Subject: Carolina Power and Light Co.
H. B. Robinson Steam Electric Plant
Licensee Event Report 82-005
Main Steam Check Valves

Enclosures: a. Form Cover Letter.
b. Instructions Sheets 82G-0131V, 82G-0132V, 82G-0133V & 82G-0134V
c. Installation List

INSTRUCTIONS TO INSTALL ROCKSHAFT ON MAIN STEAM ISOLATION VALVE, AND OR CHECK VALVE

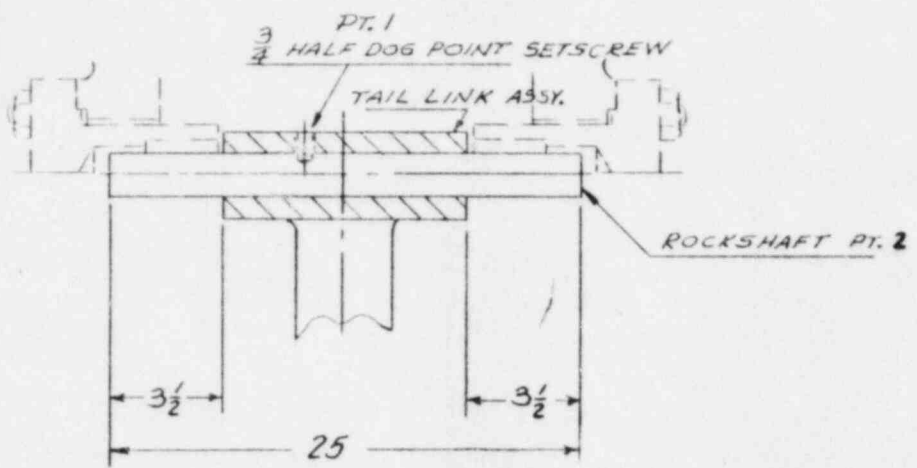
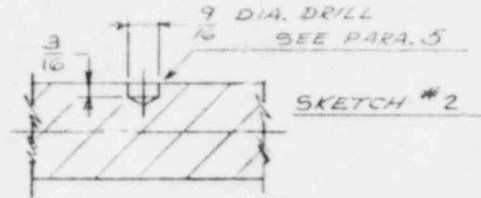
1. REMOVE HALF DOG POINT SETSCREW (OR SETSCREWS) PART 1.
2. ATTACH SLING TO "LINK AND DISC ASSEMBLY" THEN REMOVE ROCKSHAFT, PART 2. DISC AND LINK ASSEMBLY IS THEN REMOVED FROM BODY.
3. INSERT NEW SHAFT AND POSITION IT AS SHOWN IN SKETCH #1.
4. WITH A SMALL DRILL OR CENTER PUNCH MARK THE SHAFT WHERE THE SETSCREW OR SETSCREWS WILL BE LOCATED.
5. REMOVE THE SHAFT AND DRILL THE SPOT OR SPOTS PER SKETCH #2.
6. PUT "TAIL LINK AND DISC ASSEMBLY" IN THE VALVE AND INSERT SHAFT INTO LINK. LINE UP COUNTER-DRILLED HOLE IN SHAFT WITH SETSCREW HOLE IN LINK. PUT THE HALF DOG POINT SETSCREW IN AND TIGHTEN IT. STAKE THE TOP THREAD ABOVE THE SETSCREW (2 PLACES) TO KEEP THE SETSCREW FROM BACKING OUT.
7. IF A SHAFT IS REMOVED FOR INSPECTION AND FOUND TO BE SATISFACTORY FOLLOW THE ABOVE PROCEDURES AT REASSEMBLY. PARAGRAPH 6 IS MANDATORY FOR ORIGINAL OR NEW SHAFTS.

82G-0133V

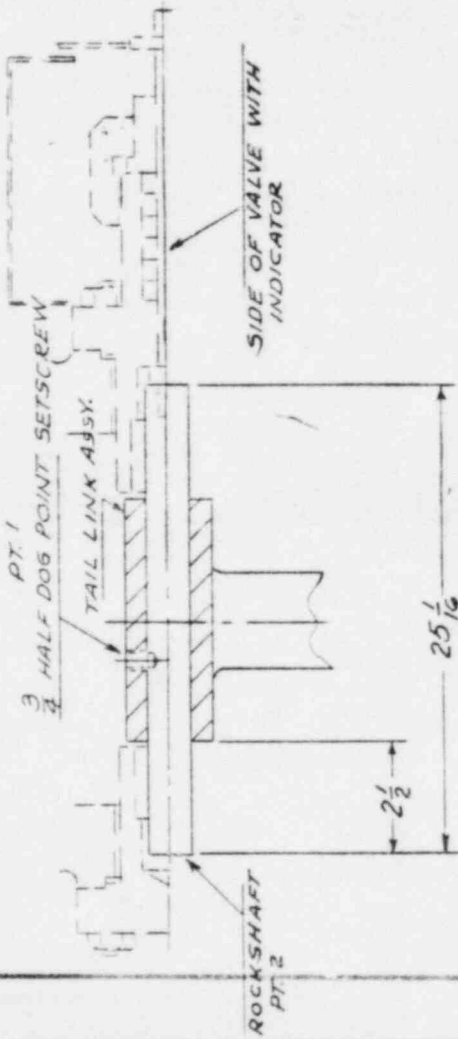
1. REMOVE HALF DOG POINT SETSCREW (OR SETSCREWS) PART 1.
2. ATTACH SLING TO "LINK AND DISC ASSEMBLY" THEN REMOVE ROCKSHAFT, PART 2. DISC AND LINK ASSEMBLY IS THEN REMOVED FROM BODY.
3. INSERT NEW SHAFT AND POSITION IT AS SHOWN IN SKETCH #1.
4. WITH A SMALL DRILL OR CENTER PUNCH MARK THE SHAFT WHERE THE SETSCREW OR SETSCREWS WILL BE LOCATED.
5. REMOVE THE SHAFT AND DRILL THE SPOT OR SPOTS PER SKETCH #2.
6. PUT "TAIL LINK AND DISC ASSEMBLY" IN THE VALVE AND INSERT SHAFT INTO LINK. LINE UP COUNTER-DRILLED HOLE IN SHAFT WITH SETSCREW HOLE IN LINK. PUT THE HALF DOG POINT SETSCREW IN AND TIGHTEN IT. STAKE THE TOP THREAD ABOVE THE SETSCREW (2 PLACES) TO KEEP THE SETSCREW FROM BACKING OUT.
7. IF A SHAFT IS REMOVED FOR INSPECTION AND FOUND TO BE SATISFACTORY FOLLOW THE ABOVE PROCEDURES AT REASSEMBLY. PARAGRAPH 6 IS MANDATORY FOR ORIGINAL OR NEW SHAFTS.

SKETCH #1

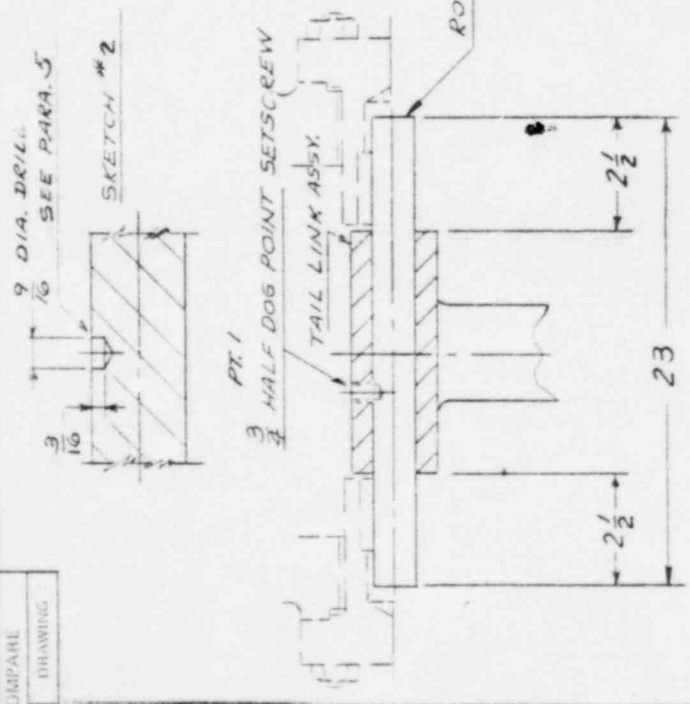
1. REMOVE HALF DOG POINT SETSCREW (OR SETSCREWS) PART 1.
2. ATTACH SLING TO "LINK AND DISC ASSEMBLY" THEN REMOVE ROCKSHAFT, PART 2. DISC AND LINK ASSEMBLY IS THEN REMOVED FROM BODY.
3. INSERT NEW SHAFT AND POSITION IT AS SHOWN IN SKETCH #1.
4. WITH A SMALL DRILL OR CENTER PUNCH MARK THE SHAFT WHERE THE SETSCREW OR SETSCREWS WILL BE LOCATED.
5. REMOVE THE SHAFT AND DRILL THE SPOT OR SPOTS PER SKETCH #2.
6. PUT "TAIL LINK AND DISC ASSEMBLY" IN THE VALVE AND INSERT SHAFT INTO LINK. LINE UP COUNTER-DRILLED HOLE IN SHAFT WITH SETSCREW HOLE IN LINK. PUT THE HALF DOG POINT SETSCREW IN AND TIGHTEN IT. STAKE THE TOP THREAD ABOVE THE SETSCREW (2 PLACES) TO KEEP THE SETSCREW FROM BACKING OUT.

1. IF A SHAFT IS REMOVED FOR INSPECTION AND FOUND TO BE SATISFACTORY FOLLOW THE ABOVE PROCEDURES AT REASSEMBLY. PARAGRAPH 6 IS MANDATORY FOR ORIGINAL OR NEW SHAFTS.

SKETCH #1

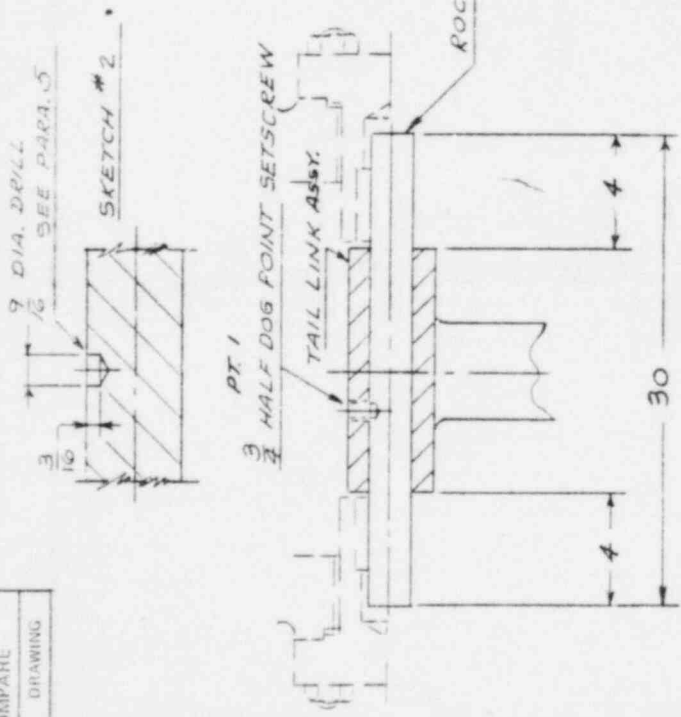
1. REMOVE HALF DOG POINT SETSCREW (OR SETSCREWS) PART 1.
2. ATTACH SLING TO "LINK AND DISC ASSEMBLY" THEN REMOVE ROCKSHAFT, PART 2.
3. DISC AND LINK ASSEMBLY IS THEN REMOVED FROM BODY.
4. INSERT NEW SHAFT AND POSITION IT AS SHOWN IN SKETCH #1.
5. WITH A SMALL DRILL OR CENTER PUNCH MARK THE SHAFT WHERE THE SETSCREW OR SETSCREWS WILL BE LOCATED.
6. REMOVE THE SHAFT AND DRILL THE SPOT OR SPOTS PER SKETCH #2.
7. PUT "TAIL LINK AND DISC ASSEMBLY" IN THE VALVE AND INSERT SHAFT INTO LINK. LINE UP COUNTER-DRILLED LOLE IN SHAFT WITH SETSCREW HOLE IN LINK.
8. PUT THE HALF DOG POINT SETSCREW IN AND TIGHTEN IT. STAKE THE TOP THREAD ABOVE THE SETSCREW (2 PLACES) TO KEEP THE SETSCREW FROM BACKING OUT.
9. IF A SHAFT IS REMOVED FOR INSPECTION AND FOUND TO BE SATISFACTORY FOLLOW THE ABOVE PROCEDURES AT REASSEMBLY.
10. PARAGRAPH 6 IS MANDATORY FOR ORIGINAL OR NEW SHAFTS.
